Planning and Zoning Commission Meeting - Regular AGENDA

Tuesday, March 09, 2021 at 4:30 PM
Ketchum City Hall
480 East Avenue North, Ketchum, ID 83340

IN RE:)
)
4th & Main St Mixed-Use Building) **KETCHUM PLANNING AND ZONING COMMISSION**
Solstice Condominiums) **FINDINGS OF FACT, CONCLUSIONS OF LAW, AND**
Design Review, Lot Line Shift, and) **DECISION**
Condominium Subdivision Preliminary Plat)
Date: March 9, 2020)
)
File Numbers: P20-118, P21-009, & P20-117)

IN RE:)
)
Warm Springs Ranch) **KETCHUM PLANNING AND ZONING COMMISSION**
Development and Rezoning Agreement,) **FINDINGS OF FACT, CONCLUSIONS OF LAW, AND**
Large Block Preliminary Plat, and Block 1) **DECISION**
Subdivision Preliminary Plat)
Date: March 9, 2020)
)
File Numbers: P 21-001, P21-003, and P21-010)

Figure 1: Eroding channel bank in project transition area.

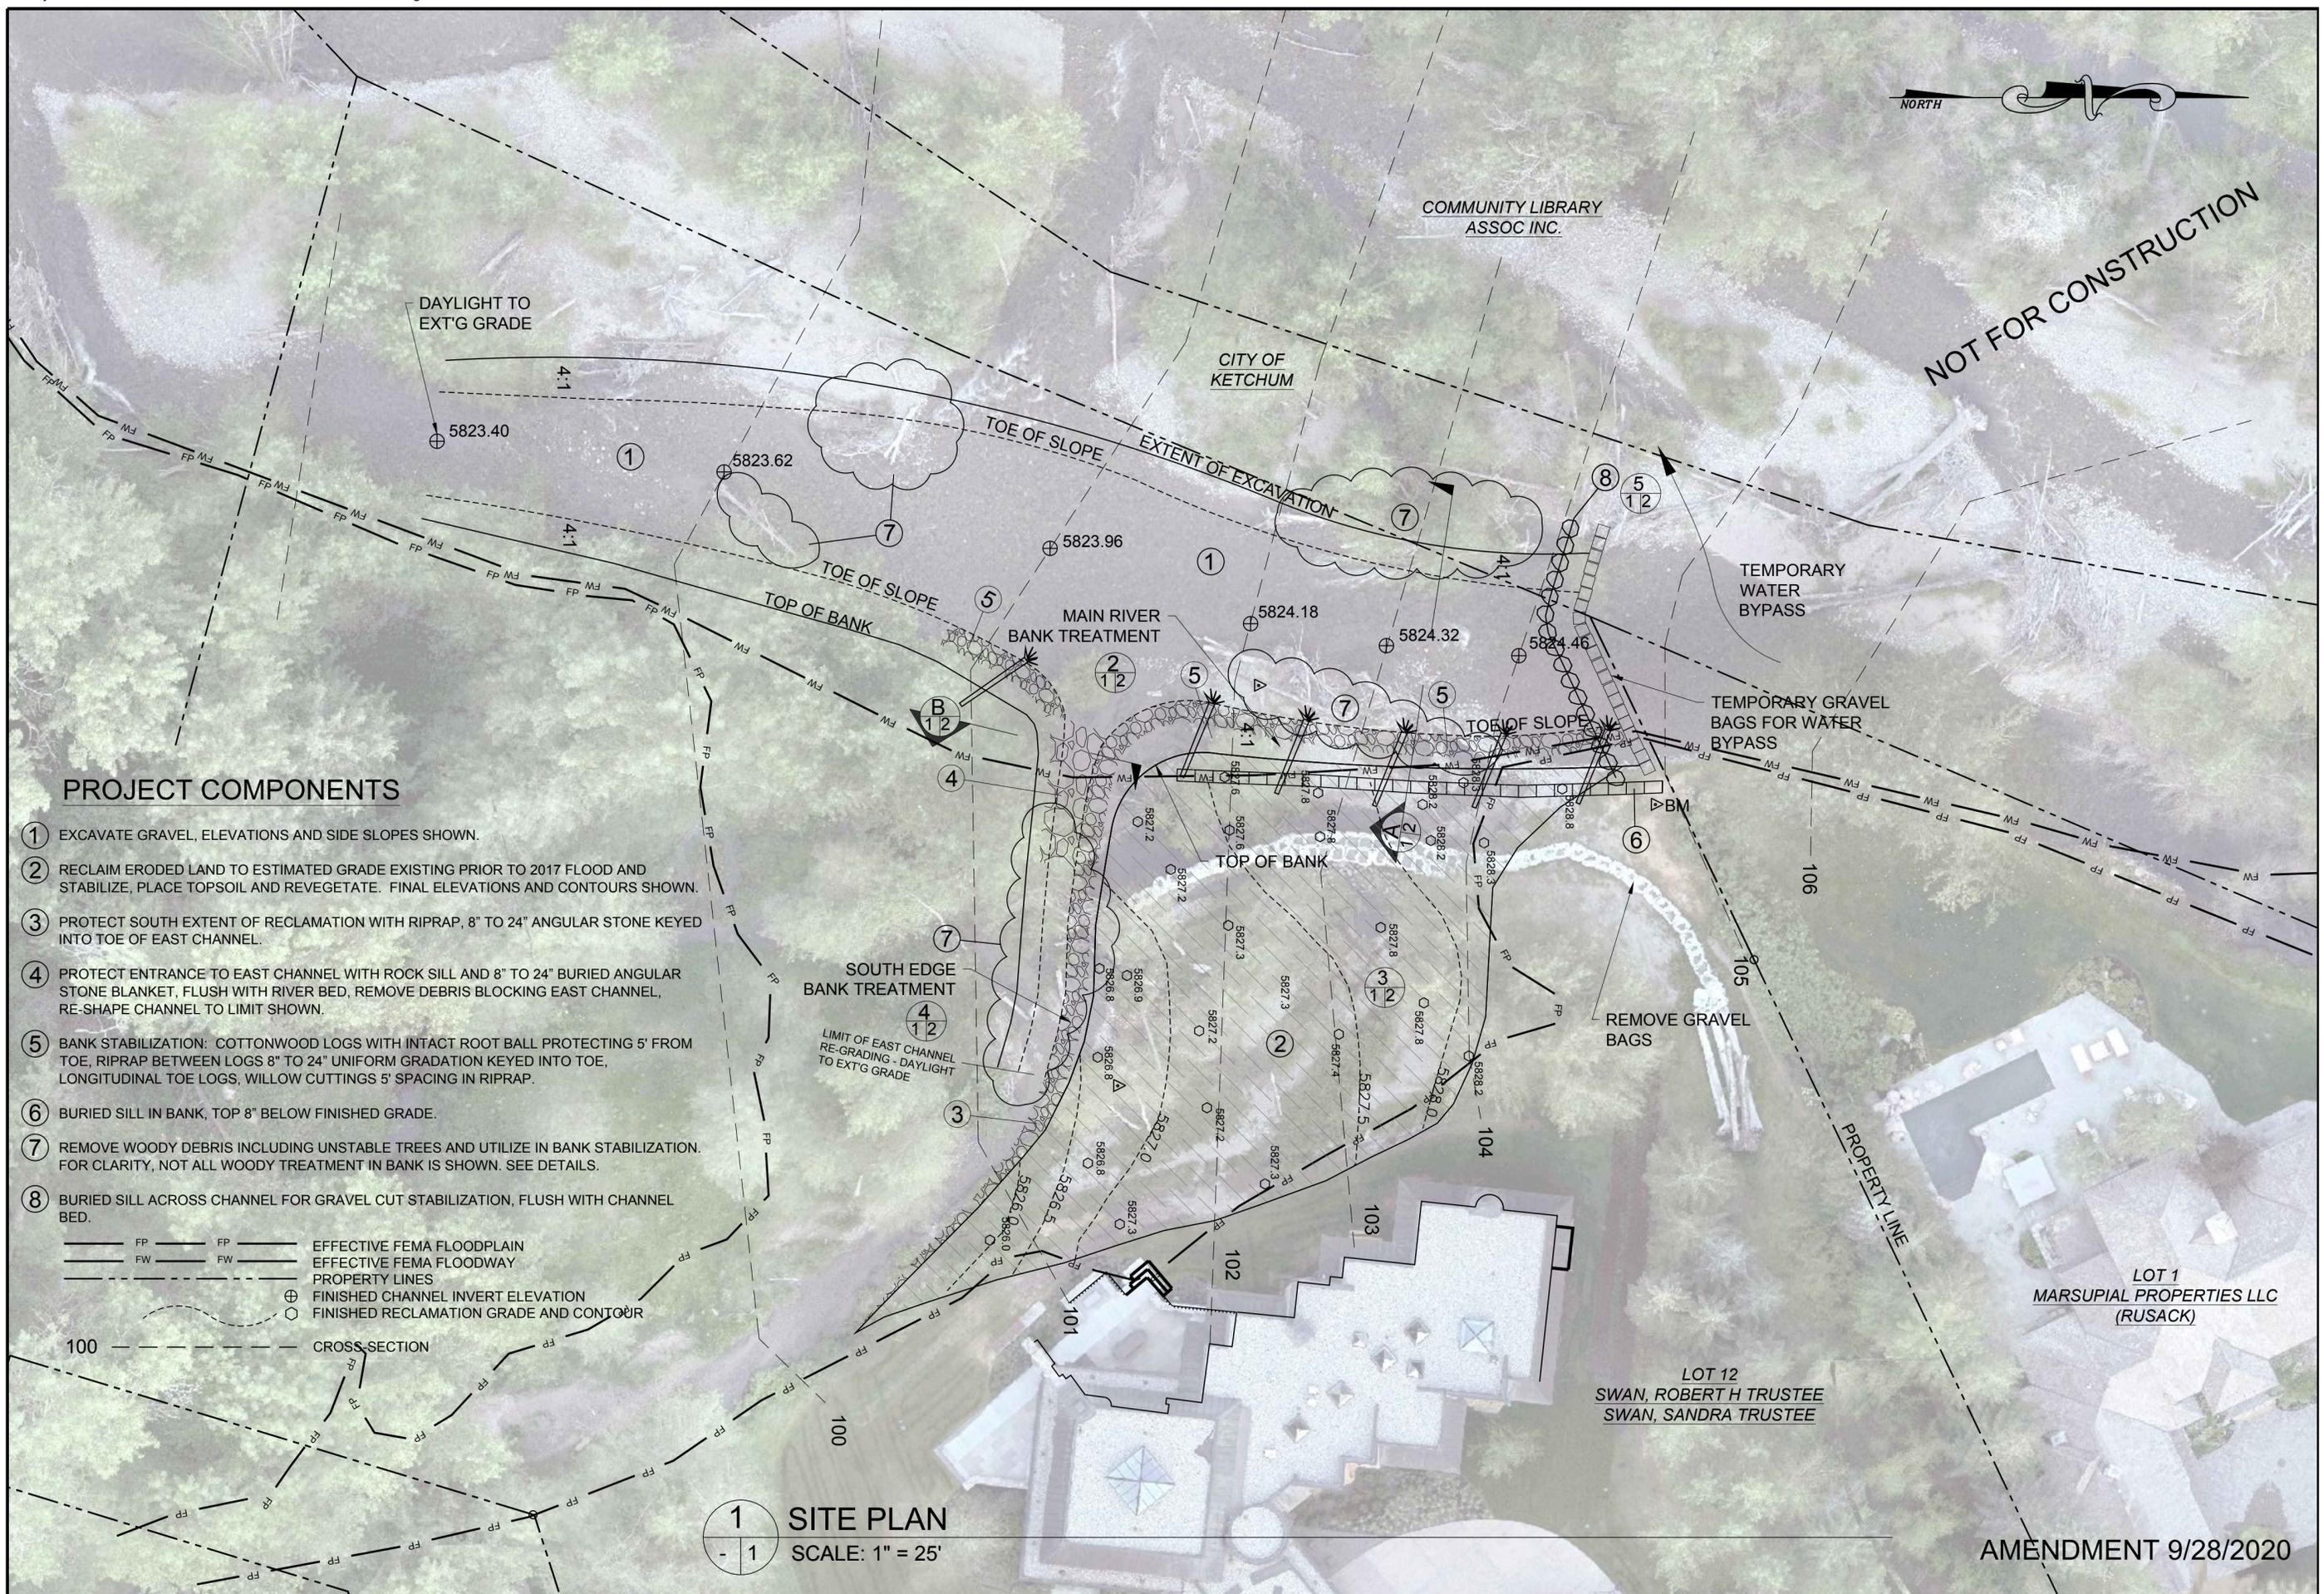
As depicted on the amended Drawings, the river channel excavation and grading work is now proposed to terminate just downstream of the shared Swan/Marsupial property line. This abrupt project transition will effectively create a vertical discontinuity in the river channel bottom between 18 and 30 inches in height over a horizontal length of approximately 15 to 25 feet as demonstrated by Sections 104 and 105 on Sheet 3 of the Amended Drawings. This resultant over-steepened section of river channel will be highly unstable and is expected to rapidly headcut upstream onto the Marsupial property. As the Amended Swan Project is no longer proposing to stabilize the approximately 60 feet of river bank through the transition section along the Marsupial property, the anticipated effect will be to further exacerbate the bank erosion issue already being experienced by Marsupial in this area as shown in Figure 1. The Amended Drawings do include a rock sill (Note 8, Sheet 3) that will serve to limit the height of the headcut to the previously mentioned 18 to 30 inches, but will not limit upstream headcut migration.

A standalone Swan Project requires a dewatering plan that backs water up onto the Marsupial property and will result in a more uncontrolled water diversion across an alluvial island into the adjacent main river channel, and may require temporary excavation as referenced in the Amended Narrative.

Based on our review, we request a denial of the Amended Swan Project until the concerns presented above have been addressed to the satisfaction of Marsupial, or both the Swan and Marsupial Projects have been coordinated to function as a single cohesive project that provides for long term channel stability and appropriate protections to the affected landowners.
